This document provides responses to the traffic and transport related matters raised by the Department of Planning, Housing and Infrastructure (DPHI) and City of Sydney Council (Council) in their submissions to the site at 13-17 Oxford Street and 2 Verona Street, Paddington (SSD – 87245208).

Table 1: Responses to DPHI comments

Table 2: Responses to Council comments

Appendix B: Bicycle Parking Specifications

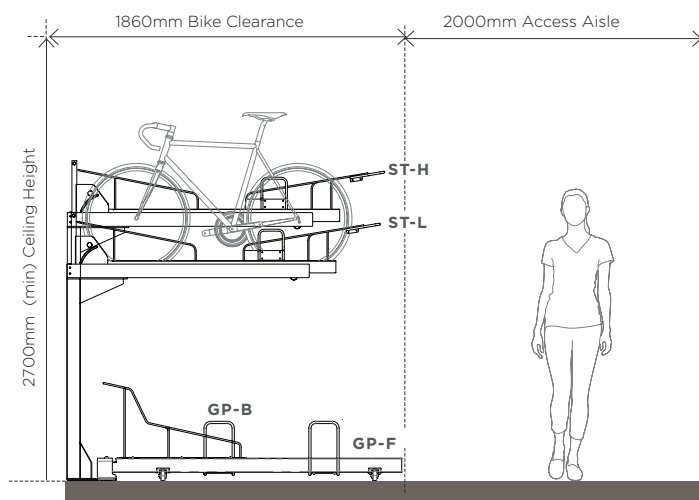
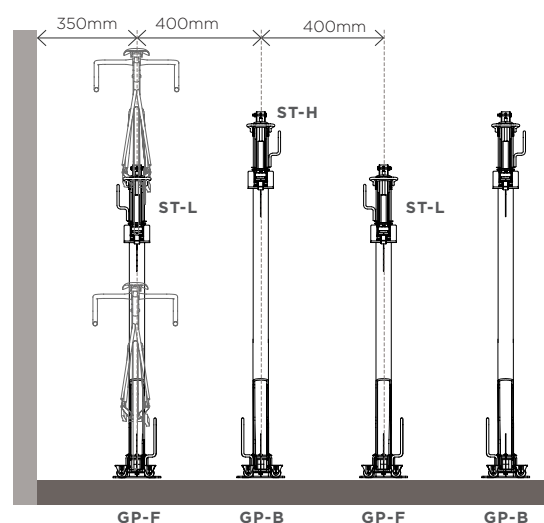
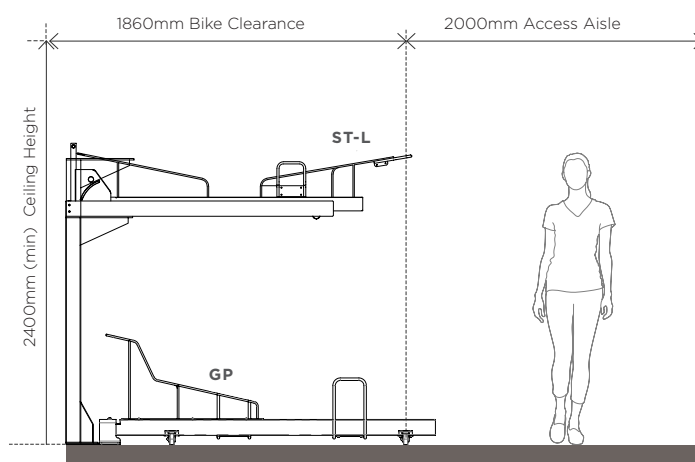
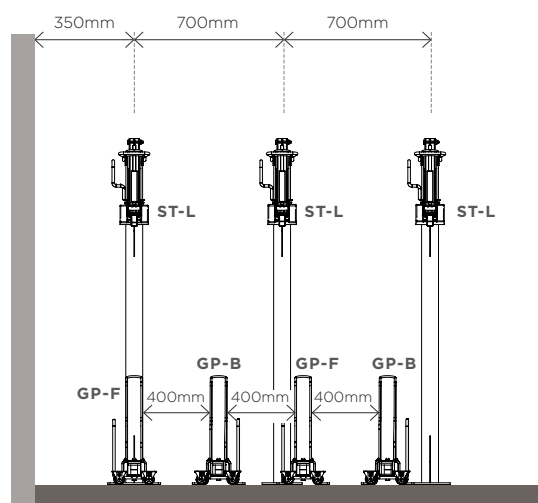
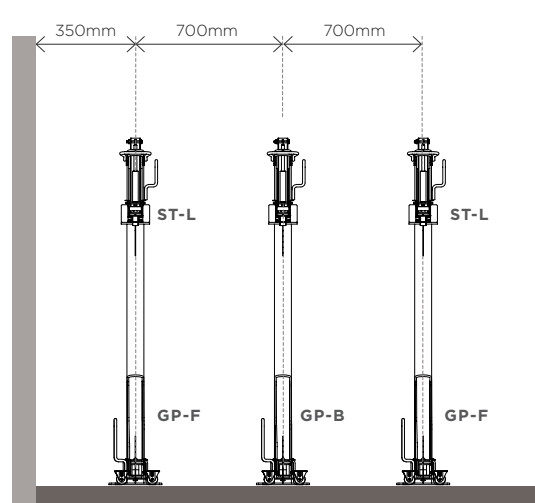
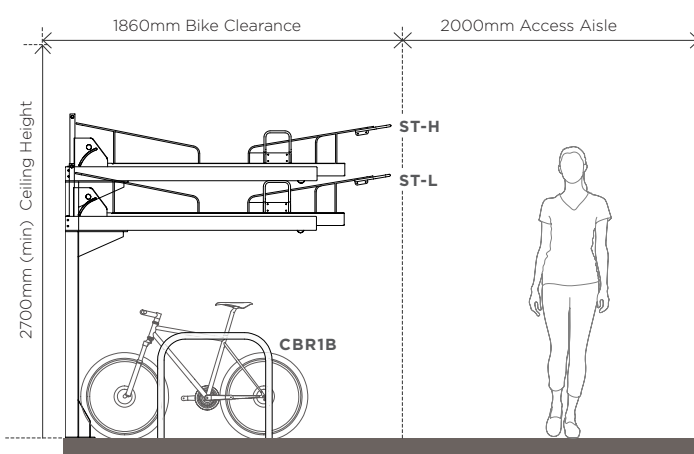
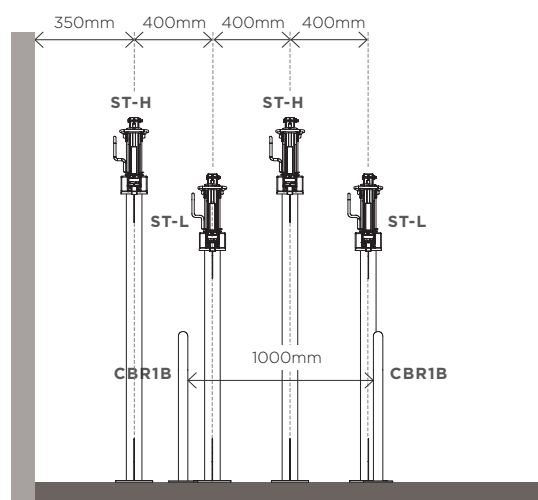
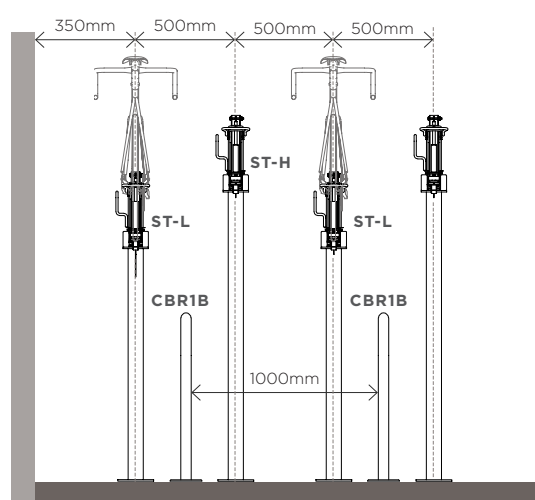
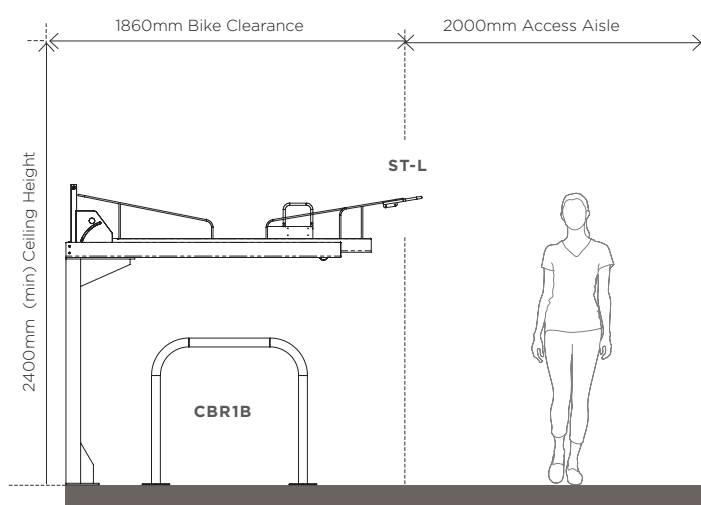
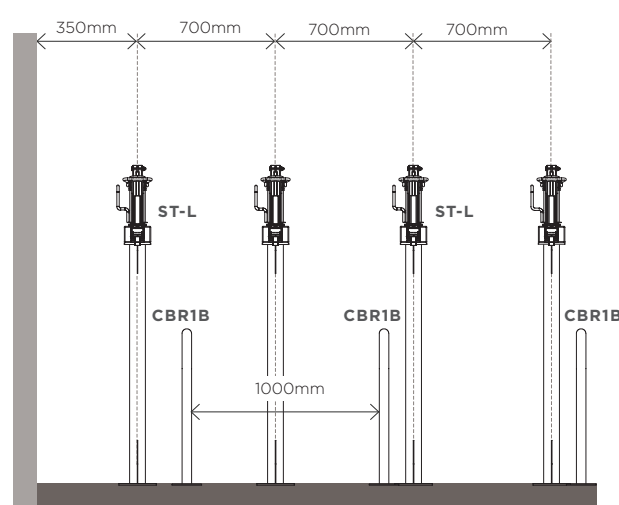
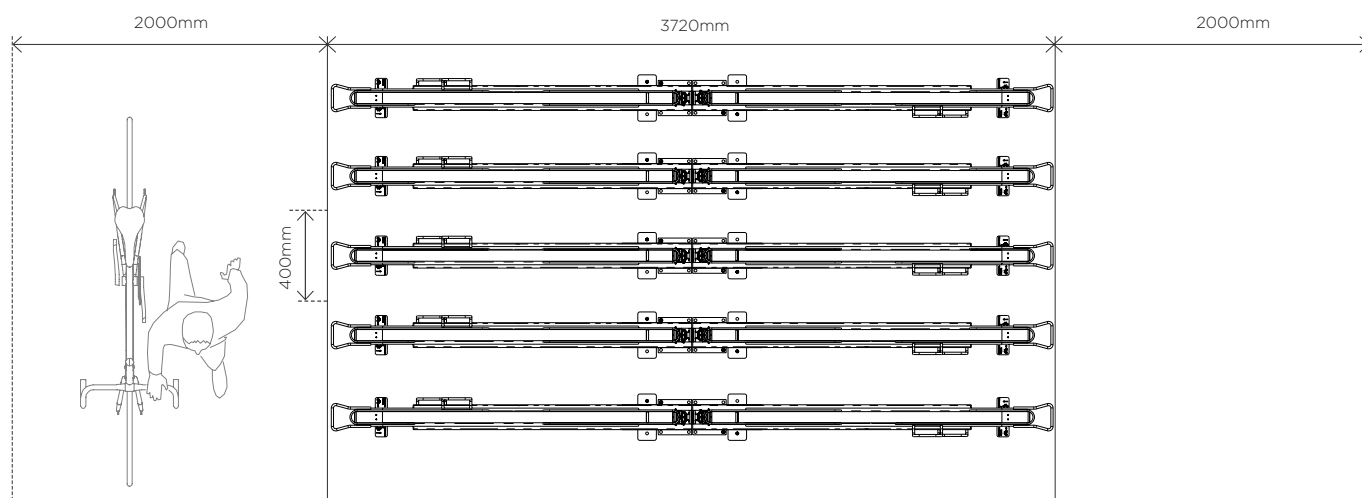
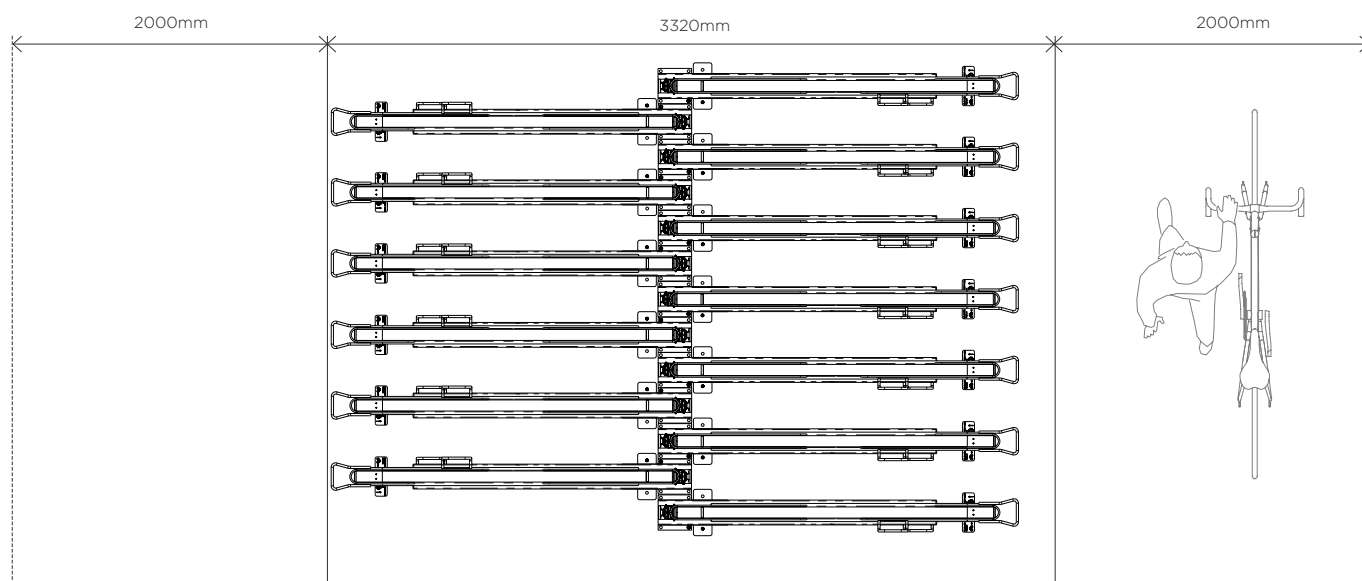
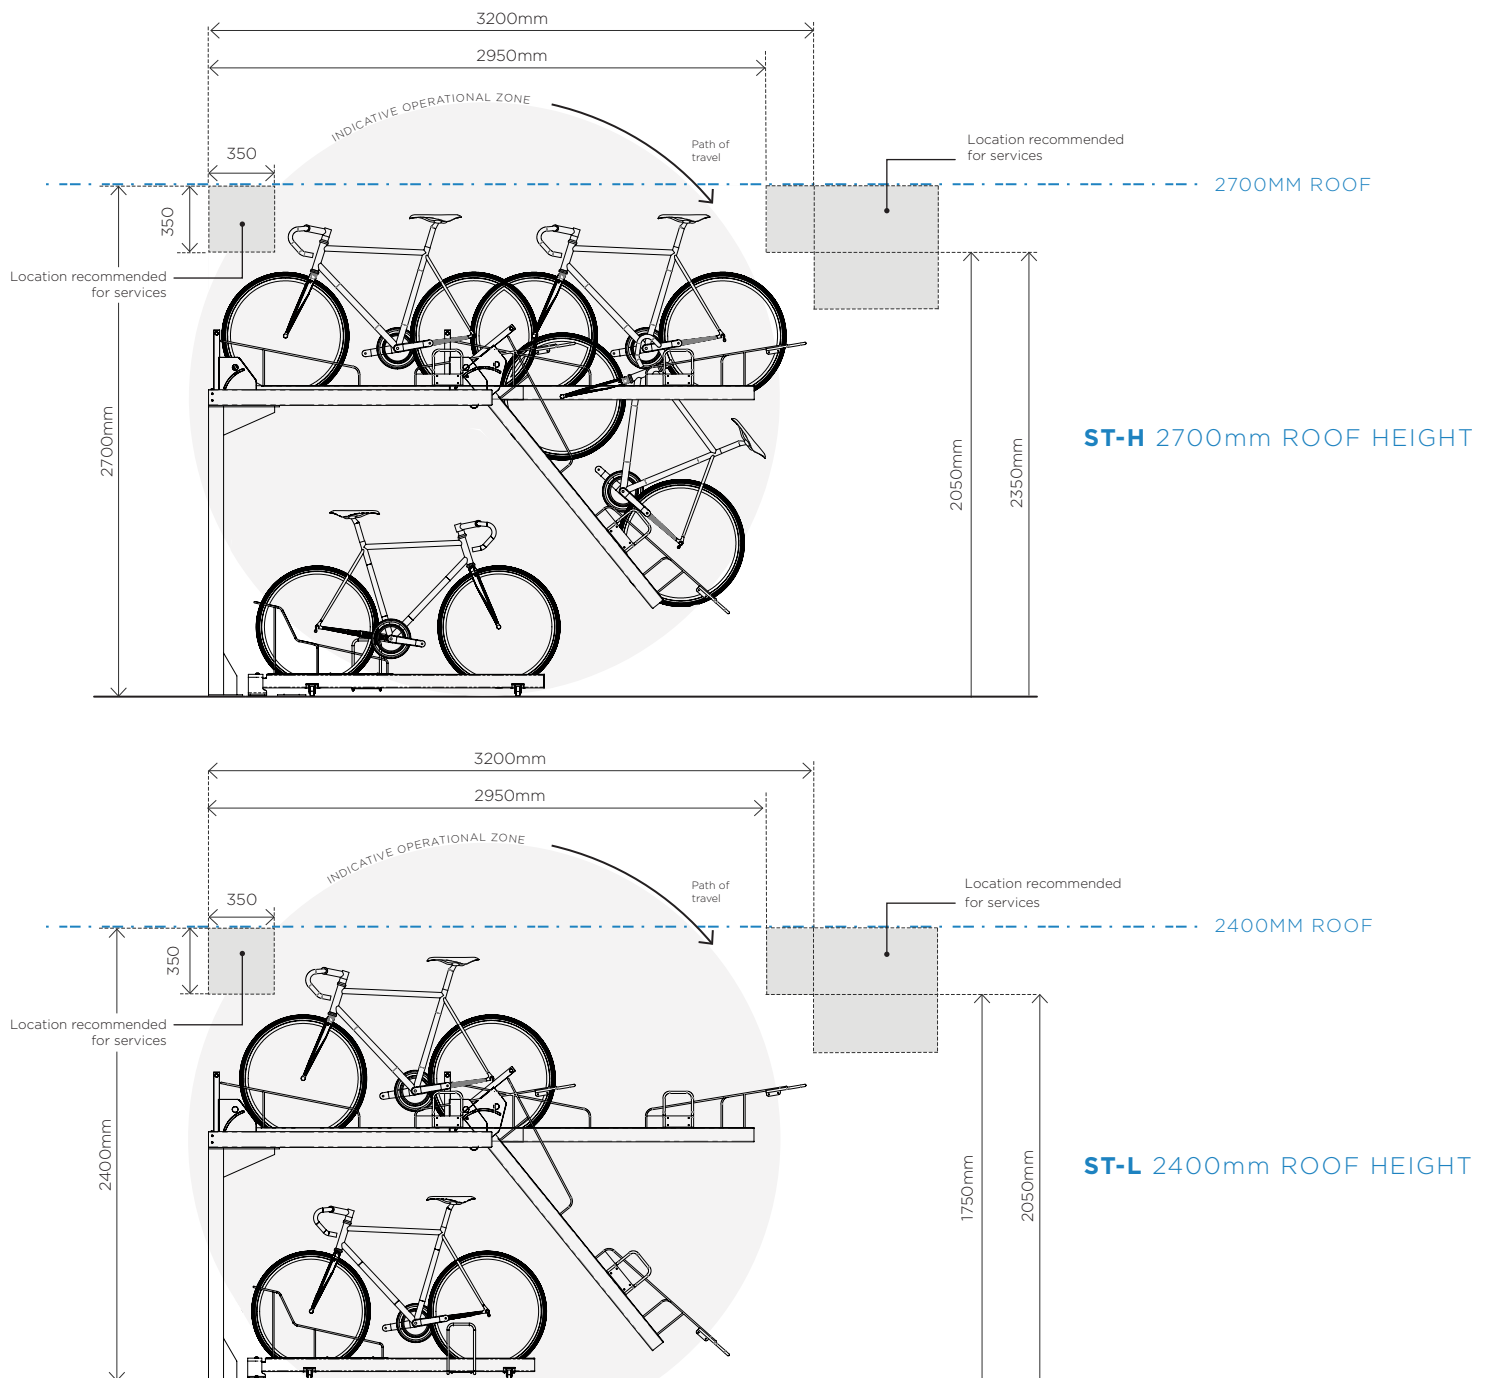
CoS Item Number	Council Comment	JMT Consulting Response
12.3	<i>Resident/ staff bicycle parking</i> The bicycle parking area on Basement 2 appears undersized to accommodate the proposed 62 bicycles. Bicycle parking manufacturers specifications should be provided to confirm compliance with AS2890.3, including height clearance if a dual height product is provided. End of Trip facilities for staff of the should also be provided within the development.	The bicycle parking numbers within the dedicated parking area on B2 have been calculated using the Cora Bike Rack product specifications as a reference, and is compliant with AS2890.3. The layout utilises the Cora ST-L dynamic upper tier, requiring a clear height of 2400mm and 700mm spacing between bicycles, in conjunction with alternating GP-F (front-in) and GP-B (back-in) lower tiers, allowing for 400mm separation between bicycles at that level. Each dashed grey box represents one bicycle at the lower tier, with the thicker lines representing one bicycle at the upper tier. Staff end of trip facilities are provided on Basement level 3 of the building.

Appendix C: Turntable Specifications

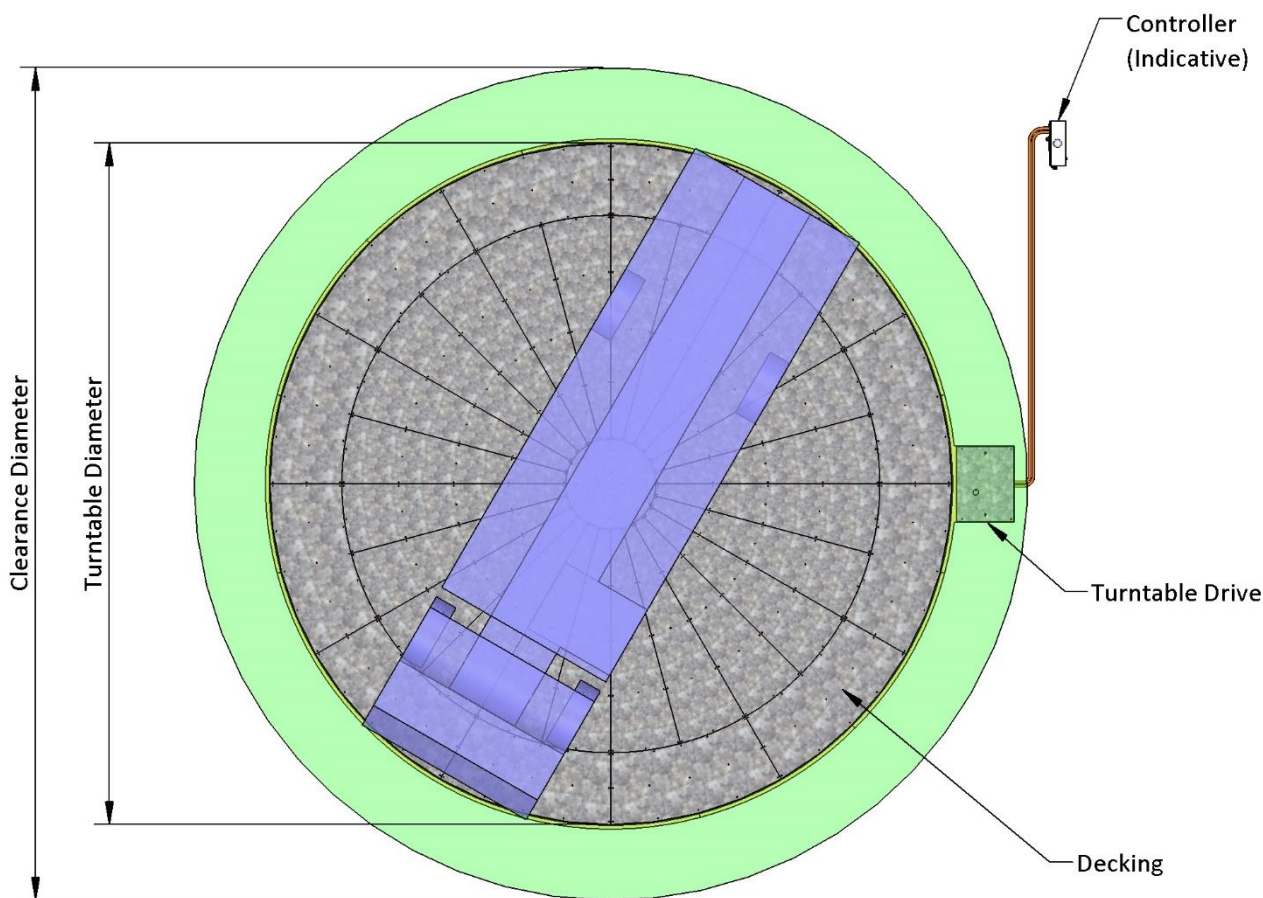
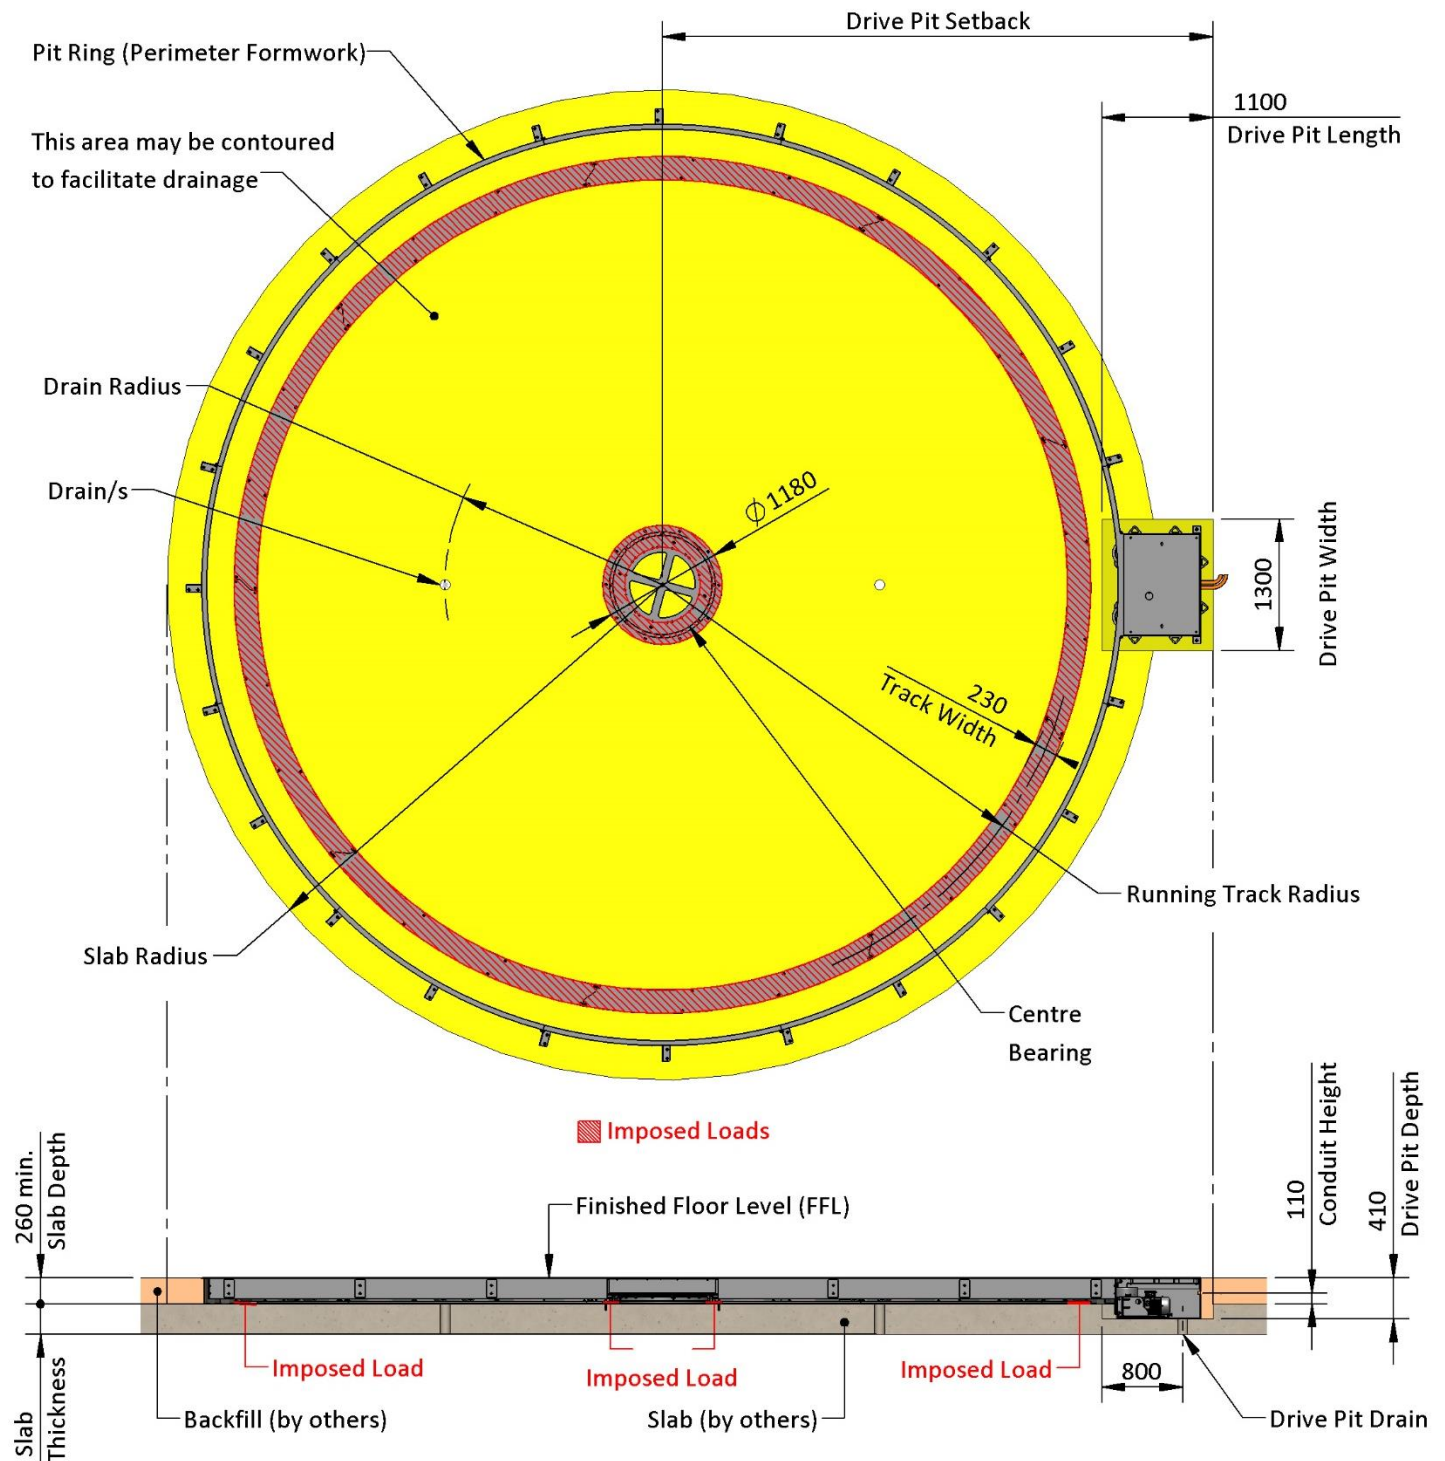
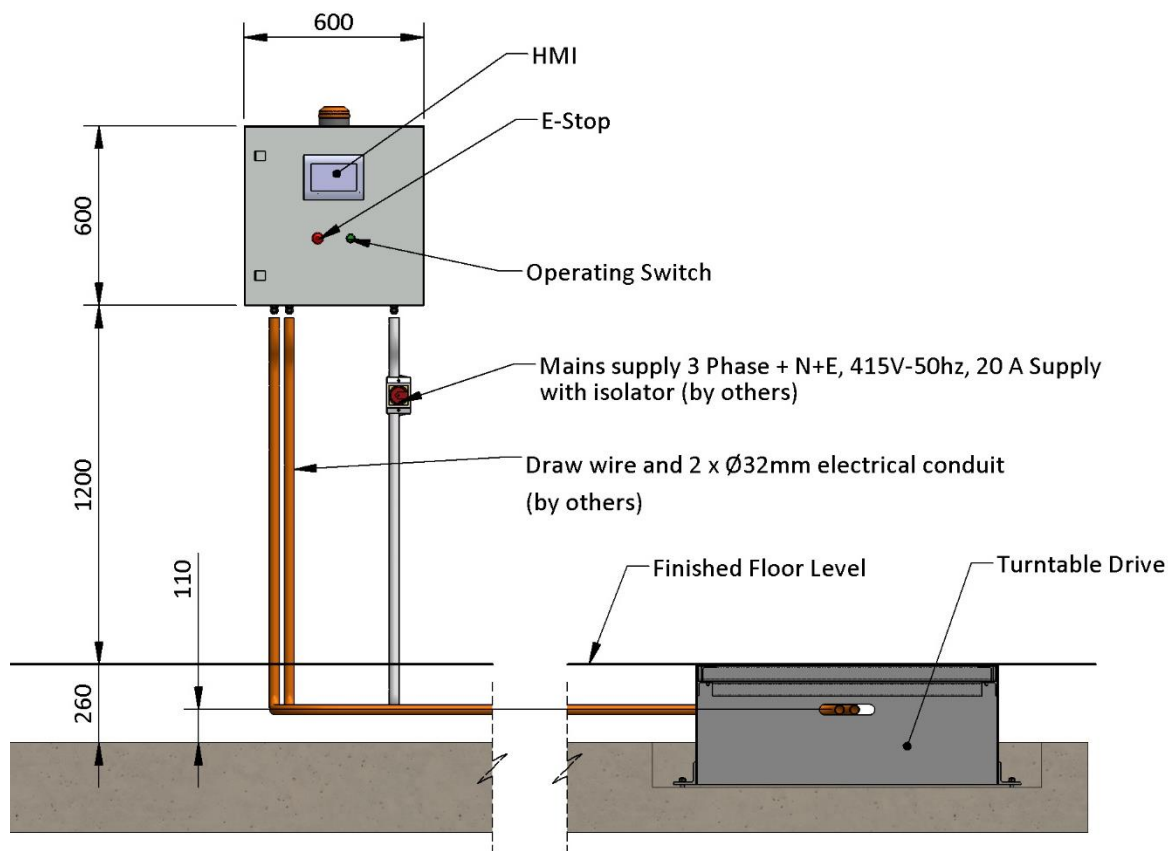
CoS Item Number	Council Comment	JMT Consulting Response
13.1	<i>Loading dock/ turntable design</i> i. The turntable manufacturers specifications are required to confirm compliance with AS2890.2 using the 10.6m long waste truck as the design vehicle. ii. A cross section of the driveway crossing and loading dock with all overhead services overlaid is also required to confirm a minimum 4m clear vertical height. iii. Confirmation that the proposed turntable meets the 30-tonne capacity structural rating.	i. The turntable manufacturers specifications are provided in Appendix C, confirming the turntable can accommodate the design vehicle being a 10.6m long waste truck ii. Refer to updated architectural package which includes the sectional plan as requested. This plan is reproduced in the image below. iii. As per the manufacturers specifications provided in Appendix C the turntable can accommodate a 30 tonne vehicle  <i>Sectional plan indicating 4m height clearance within loading dock</i>
